**BUS RAPID TRANSIT CORRIDOR (PART 2)
MOOLCHAND TO DELHI GATE JUNCTION**

**BICYCLE INFRASTRUCTURE AND SAFETY
BASED ON CYCLE AUDIT**

CONDUCTED ON 19th June / 26th June / 1st July 2009

DIMTS Ltd.

3.1.6 7980 (left figure), 8020 (right figure) LHS - No segregated Bicycle Facility Provided

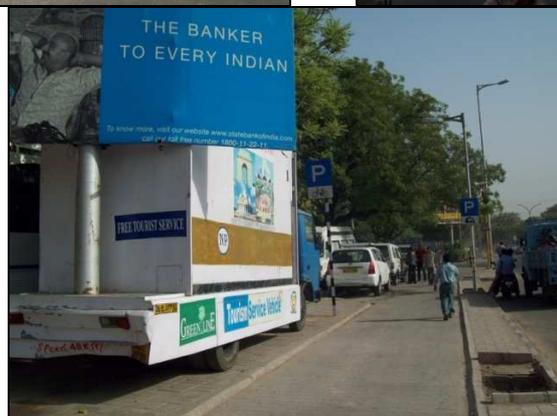
OBSERVATION / PROBLEM IDENTIFIED	<p>The cyclists are using the painted facility which is unsafe. They are next to the bus lane and a bus shelter is on this stretch. With buses stopping and people boarding and alighting the shelter, cyclists overtake the bus from the right coming in conflict with fast moving traffic coming from the ROB.</p> <p>It was informed by Mr. Gandhi that there are plans of a segregated facility for cyclists with the central shelter and land acquisition was to be taken up. However in the meanwhile the possibility of using the pedestrian path as shared facility by cyclists and pedestrians (for this short stretch) along with paint marking and signage as per design is plausible. The same is included in the drawing also.</p>
IMPLICATION	<p>High safety risk to cyclists using painted cycle track. Cyclists in painted track would also disrupt the use of bus shelters and bus lanes.</p>

SOLUTION	<p>The entire path of the cyclists should be marked over the footpath with ramps (1:12 – 1:20) for access. Existing designs/drawings and details for this location may be used.</p> <p>Tree pruning needs to be taken up at a regular basis.</p> <p>While agreeing to these solutions, ACP Traffic also highlighted the use of retro-reflective stickers on trees to ensure their visibility at night He reiterated that segregation of cyclists is required to ensure their safety.</p>

14180 LHS – Bus shelter on Cycle track, Cycle Rickshaws Parked on Footpath

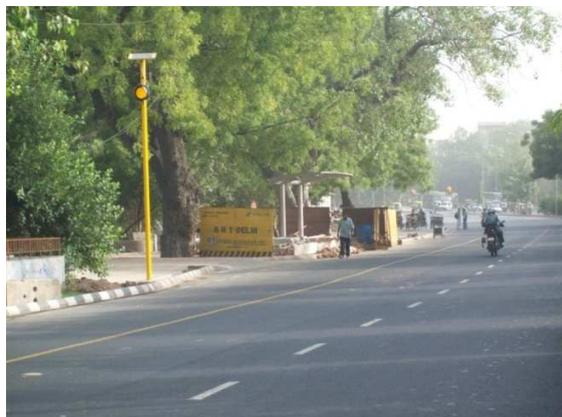
<p>PROBLEM IDENTIFIED</p>	<p>The bus shelter is constructed on the segregated cycle track. Cyclists move on the carriageway. The pedestrian path was occupied by cycle rickshaws acting as feeder to the shelter.</p>
<p>IMPLICATION</p>	<p>It is a visual obstruction, a clear encroachment of space of cyclists, cyclists move out onto the carriageway and merge with carriageway since a raised crossing and ramp to the carriageway is right next to the shelter. Safety of cyclists is affected.</p>
<p>SOLUTION</p>	<p>It has been suggested by RITES that a ramp before and after the shelter is constructed with marking for cyclists to weave with the footpath. Cyclists would move out onto the carriageway and merge with carriageway using the raised crossing 20m before the shelter.</p> <p>Since there is space at the rear of the footpath (well shaded and wide) , a rickshaw parking could be created.</p>
<p>REMARKS</p>	<p>Bus shelter was seen as an encroachment in the cycle track. The Traffic Police also commented on such actions. They saw this as a redundant effort and did not see the reason of why a formal big shelter is required to run left lanes. This could also work by installing a signage indicating a bus to stop since the entire action has been done to experiment the center and the left lane of the BRT.</p>

3.2.7 13000RHS - ITO Junction - Blind Crossing

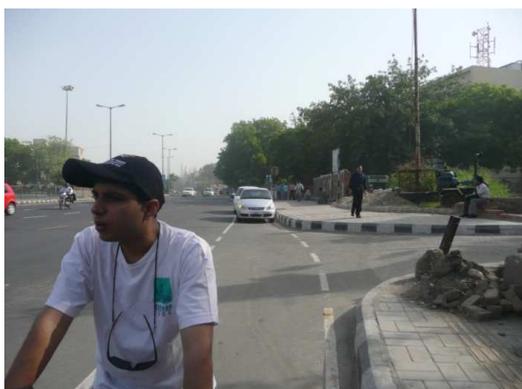
OBSERVATION / PROBLEM IDENTIFIED	Police box completely obscures sight lines for cyclists and pedestrians crossing the road
IMPLICATION	Cyclists would face a collision with motorists taking a left turn, due to a delhi traffic police room, coming in the line of sight.
SOLUTION	As proposed in the previous point, cyclists should be closer to the carriageway which may possibly require shifting of the BOT toilet. In case the same is not possible, railings and the traffic police booth may need to be removed to restore the line of sight.
